North Central Texas  
Council of Governments

**Recommended Amendments to the  
2021~~18~~ International Residential Code**  
North Central Texas Council of Governments Region

The following sections, paragraphs, and sentences of the 2021~~18~~ International Residential Code are hereby amended as follows: Standard type is text from the IRC. Underlined type is text inserted. ~~Lined through type is deleted text from IRC.~~ A double asterisk at the beginning of a section identifies an amendment carried over from the 2018~~15~~ edition of the code and a triple asterisk identifies a new or revised amendment with the 2021~~18~~ code.

**\*\*Figure R602.6.1; delete the figure and insert the following figure:**

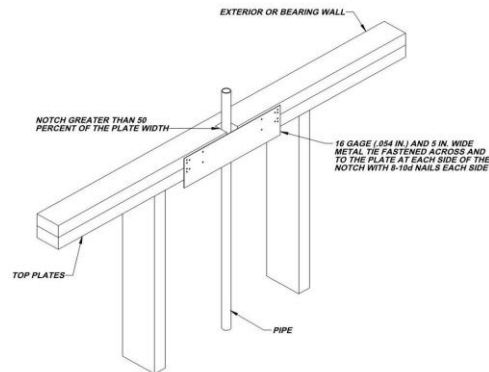
**R602.6.1 Drilling and notching of top plate.** When piping or ductwork is placed in or partly in an exterior wall or interior load-bearing wall, necessitating cutting, drilling or notching of the top plate by more than 50 percent of its width, a galvanized metal tie not less than 0.054 inch thick (1.37 mm) (16 Ga) and 1-1/4 inches

~~(38) mm~~ 5 inches (127 mm) wide shall be fastened across and to the plate at each side of the opening with not less than eight 10d (0.148 inch diameter) having a minimum length of 1 ½ inches (38 mm) at each side or equivalent. Fasteners will be offset to prevent splitting of the top plate material. The metal tie must extend a minimum of 6 inches past the opening. See figure R602.6.1. {remainder unchanged}

(Amendment to 2015 IRC carried forward to 2018 IRC also provides additional assurance of maintaining the integrity of the framing by spreading the nailing pattern.)
